Access Compliance Report

Public Rights-of-Way

(Curb Ramps)

Intersection ID: 2868	Main Street: BELL'S_MILL_DR	Cross Street: TAYMOUTH_LN	Location: S
ADA ID: 851C941DEAA7	Ramp Type: PerpDiag	Initial Pass/Fail: Pass	Overall Compliance: No
			Severity Score: 17.75

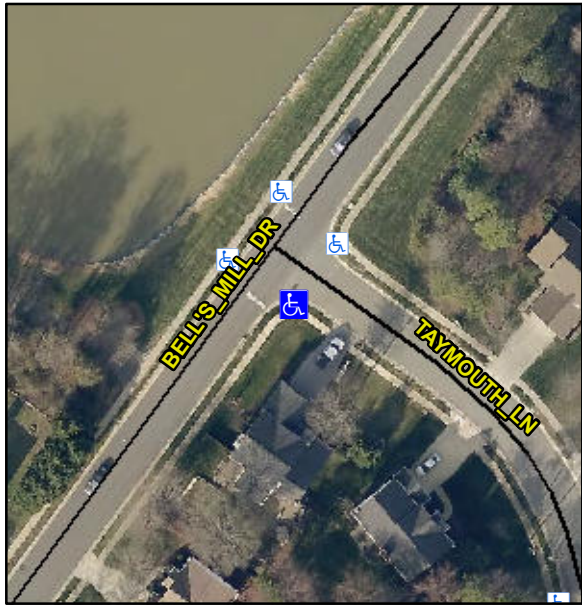
Codes/Mitigation Info/Possible Solution		Field Measurements/Component Compliance						
	Possible Solutions:		Compliance	Description	Data	Compliance	Description	Data
	Remove & Replace Curb Ramp With Two New Directional Ramps or Equivalent.		N/A	Ramp Length (in)	48.0	Yes	Ramp Slope (%)	6.0
			Yes	Ramp Width (in)	48.0	No	Ramp XSlope (%)	3.7
			N/A	Flare Type LT	Sloped	N/A	Flare Type RT	N/A
			N/A	Flare Slope LT (%)	3.9	N/A	Flare Slope RT (%)	11.6
			N/A	Flare Traversable LT?	No	N/A	Flare Traversable RT?	No
			Yes	Landing Length (in)	50.0	No	DWS Provided?	No
			No	Landing Width (in)	22.0	N/A	DWS Contrast?	No
			Yes	Landing Slope (%)	0.5	N/A	DWS Length (in)	N/A
			No	Landing X Slope (%)	3.1	N/A	DWS Full Width?	No
Surveyor Notes:		N/A	N/A	Landing Curb? (Y/N)	No	N/A	DWS Offset (in)	N/A
PROW/ADA:			N/A	Shared Landing?	No			
Not Found, R304.5.3, R304.2.1, R305, R302.7.2		Yes	Gutter Ponding?	No	Yes	Gutter Slope (%)	0.6

No	Gutter Lip Ht (in)	0.5	Yes	Gutter X Slope (%)	1.8	
		N/A	Painted X Walk1?	No	N/A	Painted X Walk2?	No	
			X Walk 1 Direction	To NE		X Walk 2 Direction	To NW	
		N/A	X Walk 1 Width (in)	N/A	N/A	X Walk 2 Width (in)	N/A	
			X Walk 1 Slope (%)	2.0		X Walk 2 Slope (%)	4.8	
			X Walk 1 X Slope (%)	3.1		X Walk 2 X Slope (%)	2.1	
		N/A	Ramp inside XWalk1?	N/A	N/A	Ramp inside XWalk2?	N/A	
			Road Slope (%)	0.4	N/A	Clear Space?	Yes	
			Road X Slope (%)	3.3	N/A	Clear Space to XWalk (in)	N/A	
		Yes	Any Obstructions?	No	Yes	Storm Grate/Utility Hazard?	No	
			Obstruction Type			Storm Grate/Utility Type		
					N/A		N/A	
					Yes	Surface Condition? (G/P)	Good	
Total Cost:		\$	3200.00
